Block 7

1. Inconsistent plans:

Proposed typical floor plan - Buildings 11 and 12

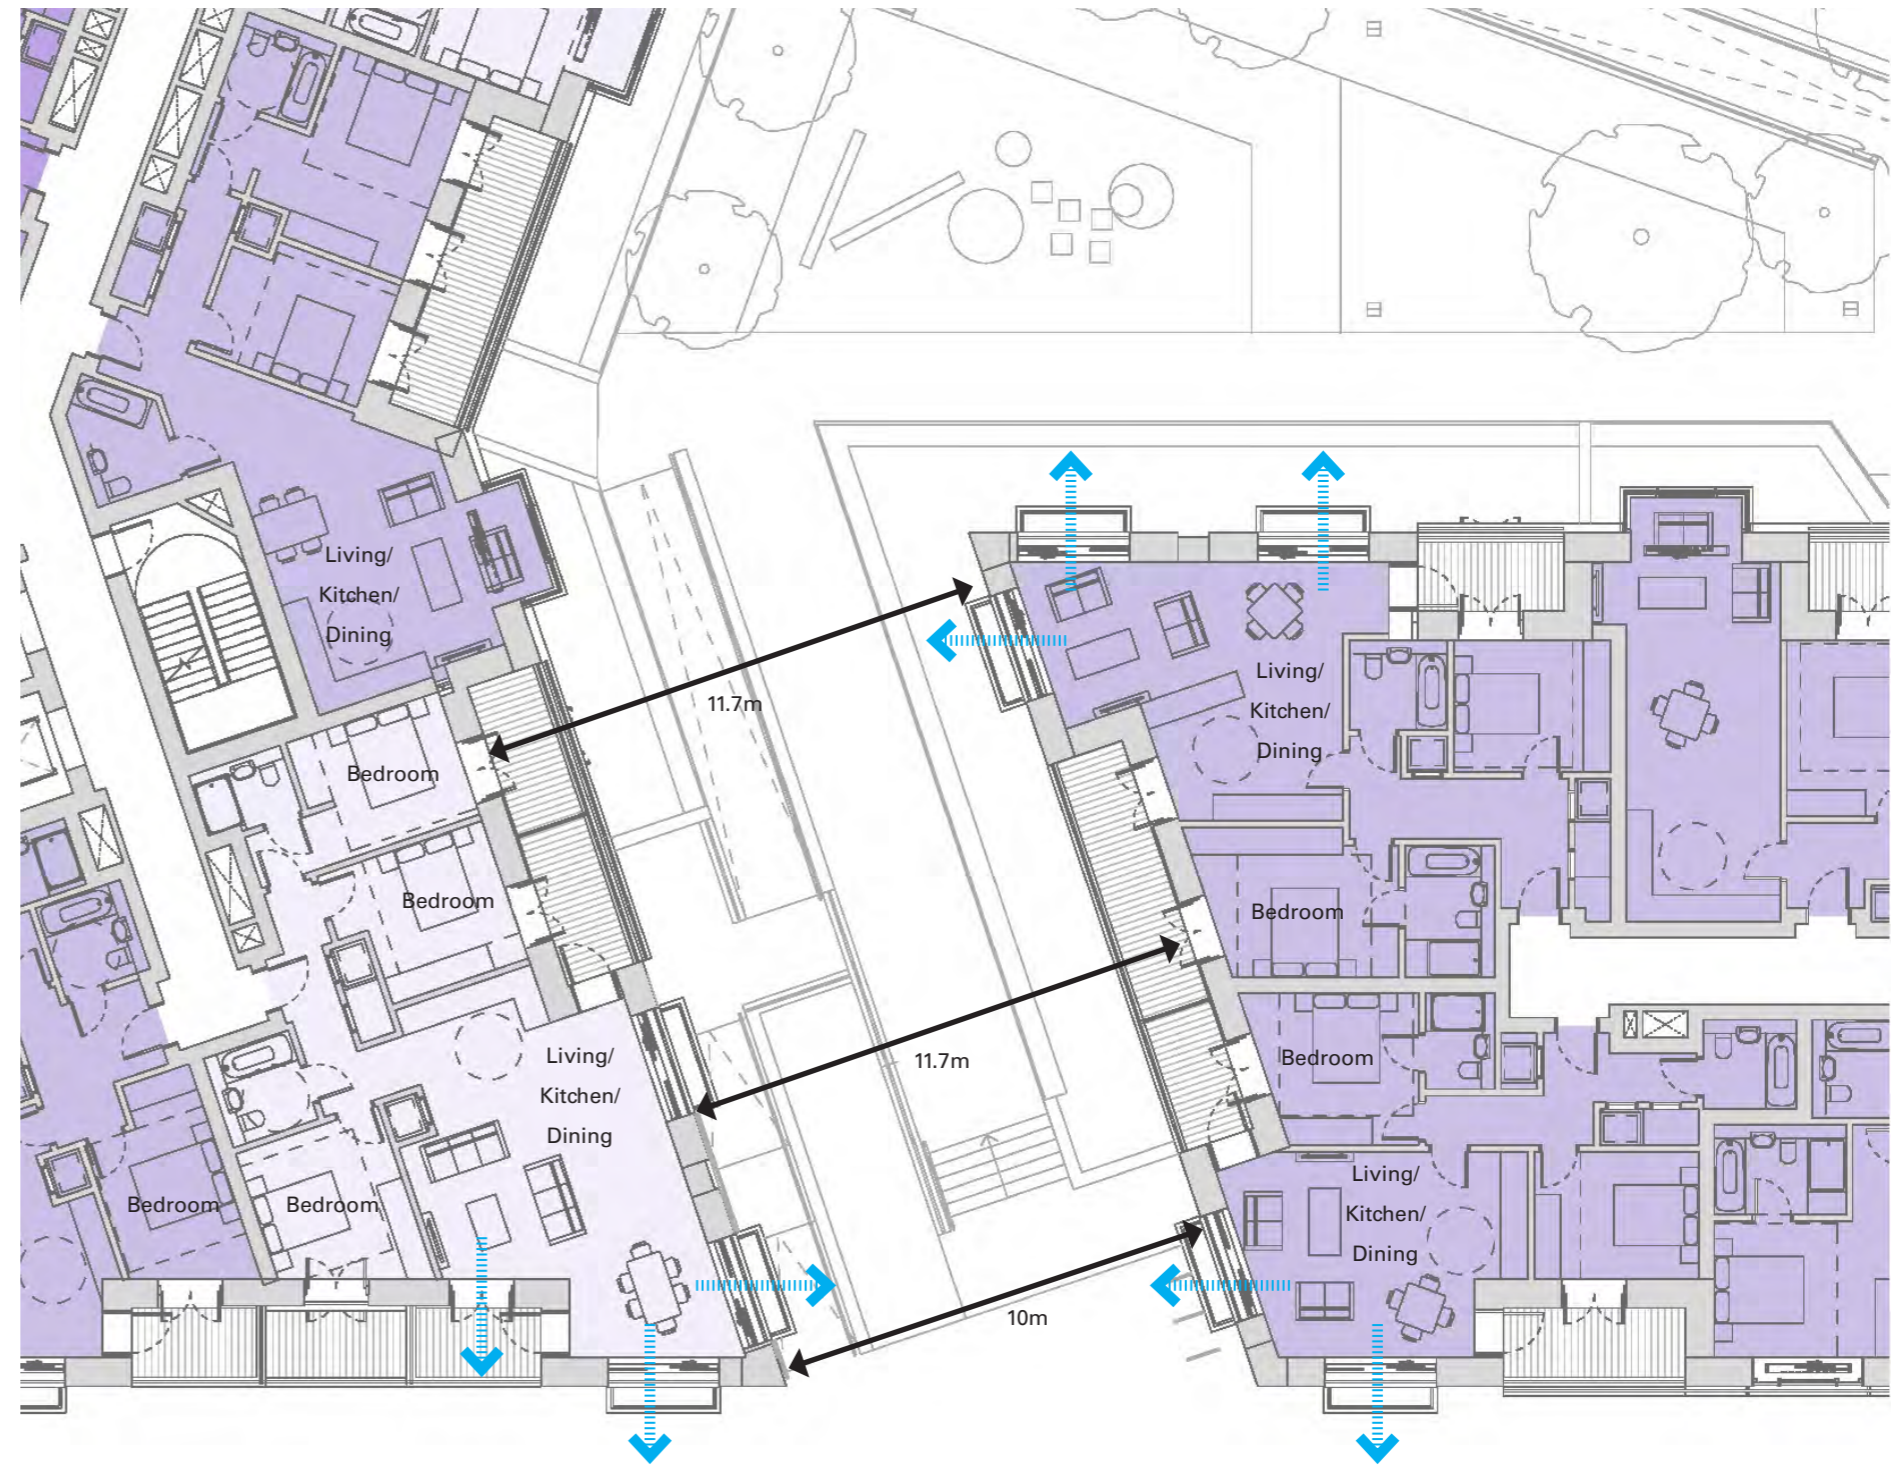
2. Block 11 with Block 12: Only 10m gap between and single aspect. Unacceptable living conditions.

3. Block 11 with 8: Only 15m and single aspect. Unacceptable living conditions.

Please refer to response to item 14 on Building 6 for an explanation of street widths.

We would note that all facing units are dual aspect and that living rooms are located on the corners of each of the units and therefore benefit from dual aspect. Bedrooms are provided on the set back areas of façade, are set apart by more than 13m and are screened by balconies and balustrades.

Please see section dedicated to 'Proximity of Buildings'.

Illustrative perspective view looking east along Mortlake High Street

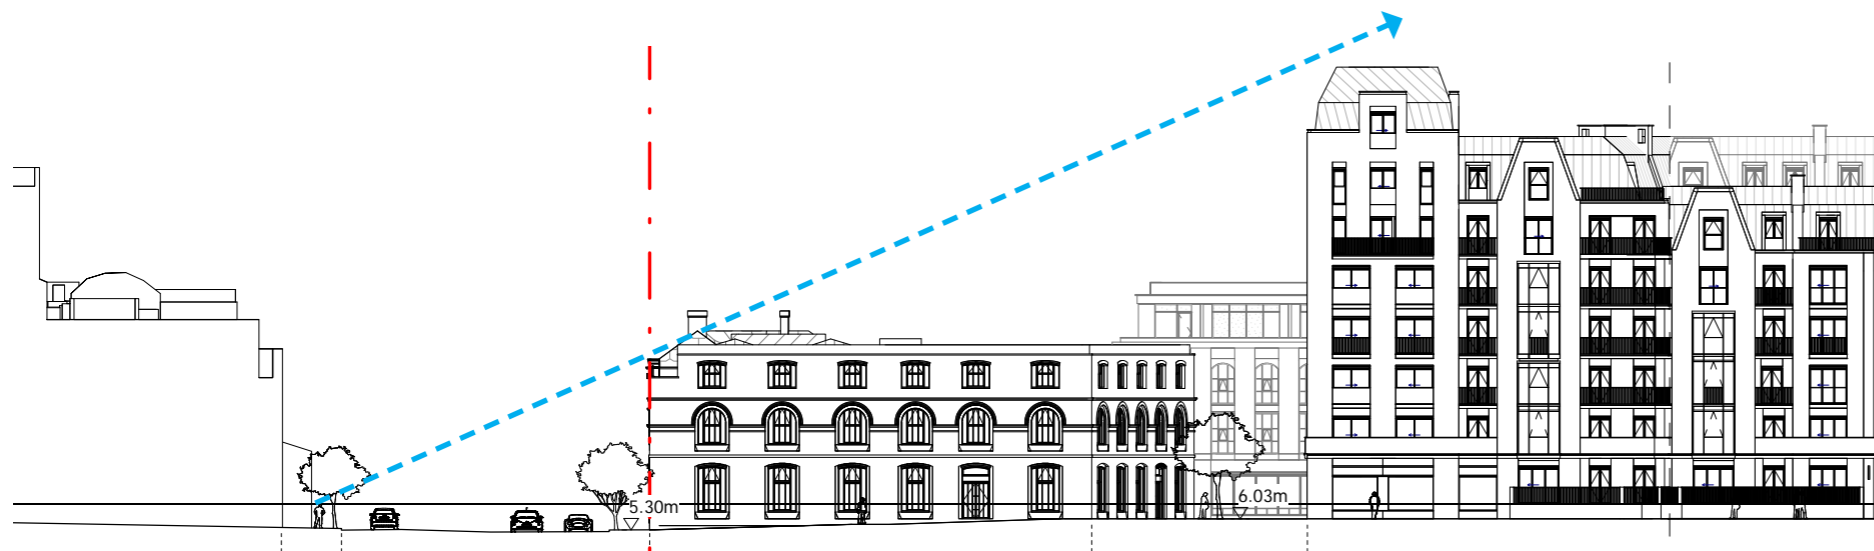
1. To the rear of the Jolly Gardiners PH, heights appear to increase rather suddenly which detracts from the setting of the BTM. Height of buildings in relation to the Jolly Gardiners PH & other BTM PH opposite) - Lower unless can be justified.

Please refer to response to comments on Block 13. You will notice that the visualisation below demonstrates that the proposed massing will not visually dominate the view of the existing public house building.

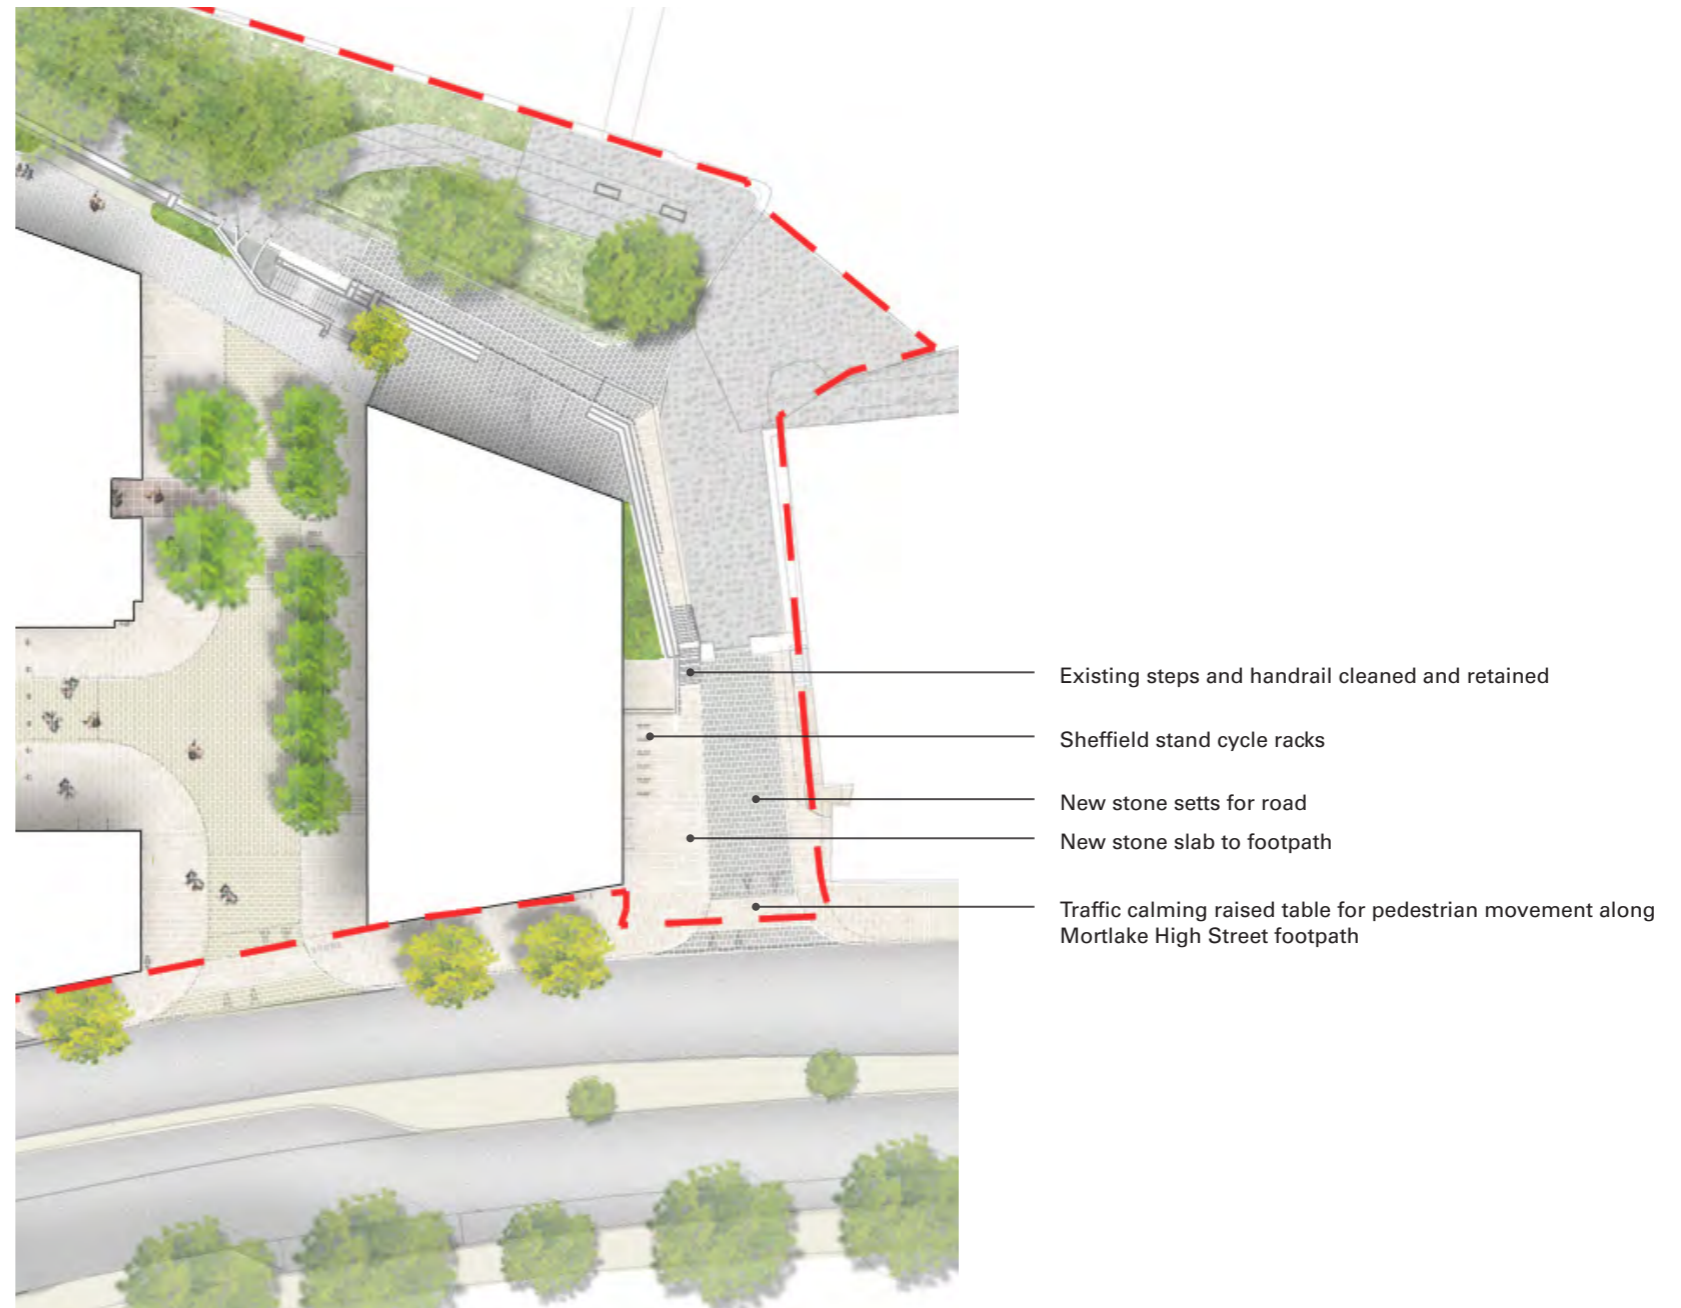
1. Bulls Alley; Whilst this appears acceptable from the riverside, the approach from the High Street is poor, needs improvement and detail.

While the Flood Barrier is retained in situ, we have proposed a number of amendments to this corner of the site and Building 9, following discussions with Environment Agency regarding flood protection. This has resulted in changes to the Rowing Clubhouse and access and storage for boats.

A number of improvements had been proposed to the Tow Path at this end of the site, including upgrading pavement and historic information related to the existing cobbles and rail tracks from the Brewery crane and remnants of the wharf in this location. Refer to Tow Path plans below.

On the High Street side of the flood gates, pavement upgrade is proposed, to define vehicle and pedestrian access, provide a raised table to accentuate pedestrian priority along the High Street and added cycle parking stands in this area. In addition, the existing wall will be cut back and amended to suit the new building B9 configuration.

Section AA

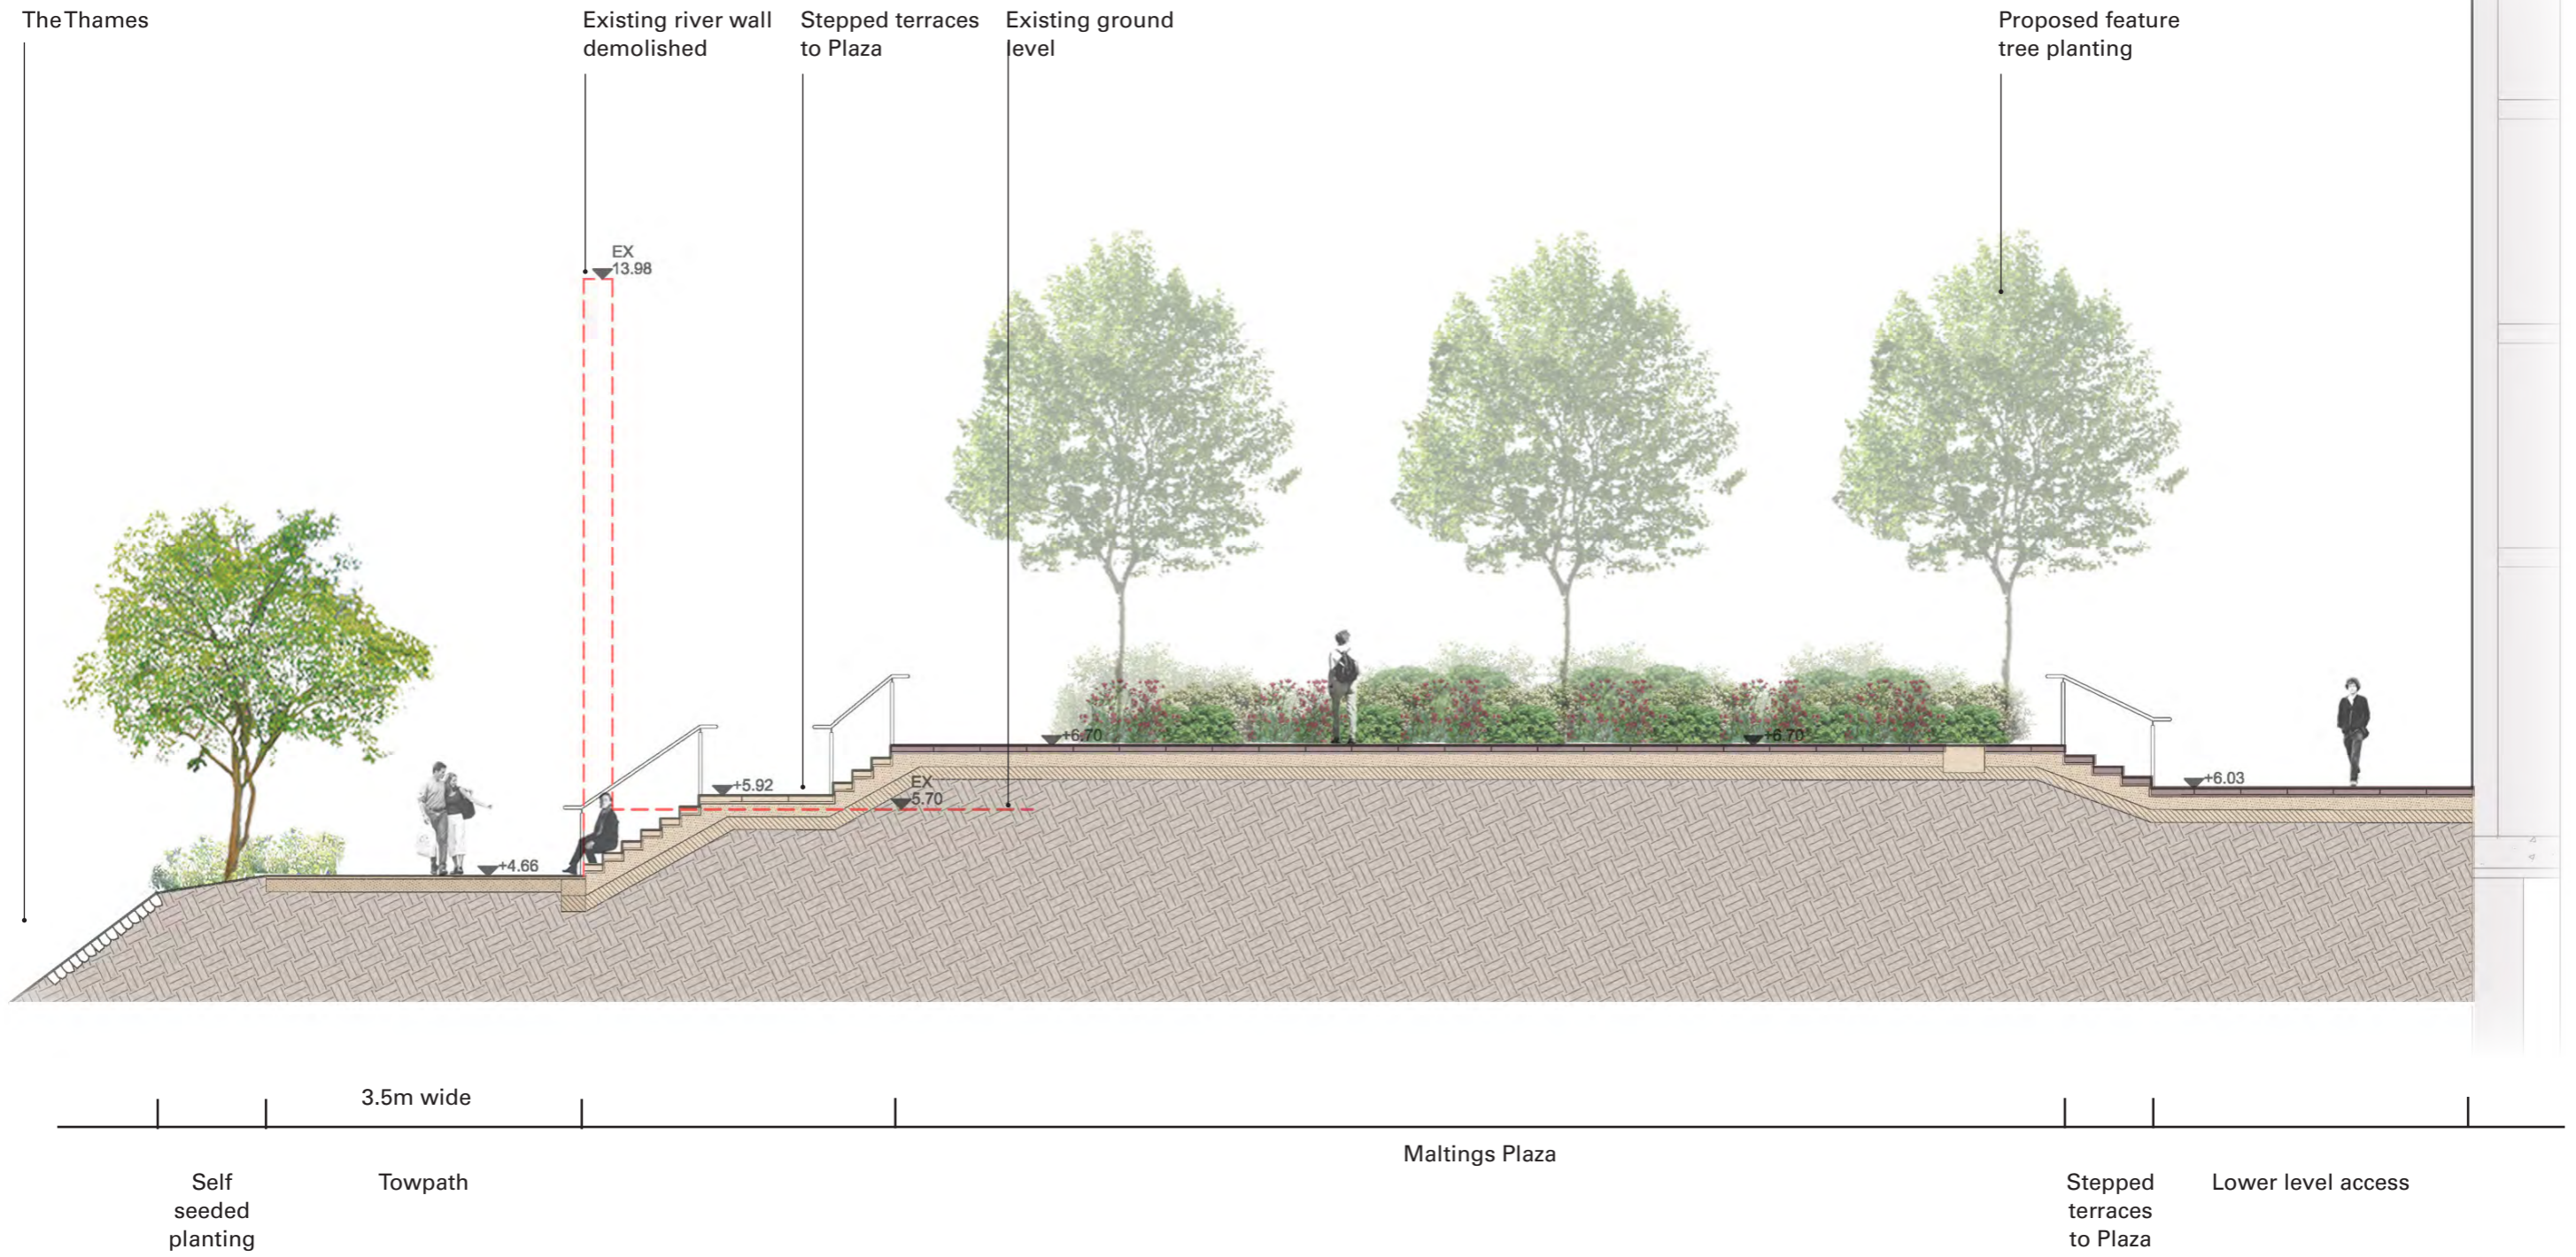
3. Malting Plaza – need to ensure landscaping (including features) does not limit the use of the space.

Noted – we have designed the layout of this important public realm to provide a number of spaces within the larger square, separated by changes of level, planting or access routes. The layout allows the space to be used in a variety of ways, accommodating a large festival or performance, temporary tiered seating for the Head of the River rowing race, smaller exhibitions or markets and individual groups enjoying the facilities and interactive play / water features.

The stepped and ramped access link from Plaza to Towpath also provides informal seating opportunities and viewing to river activities.

The paved areas also provide a contained seating and outdoor dining space associated with the proposed Cafe in the ground floor of the restored building and other use areas along the southern face of the building, related to the potential heritage or community uses inside the ground floor.

We believe the overall design works well to allow large or small groups to occupy the spaces, or a large crowd or festival to utilise the whole space.
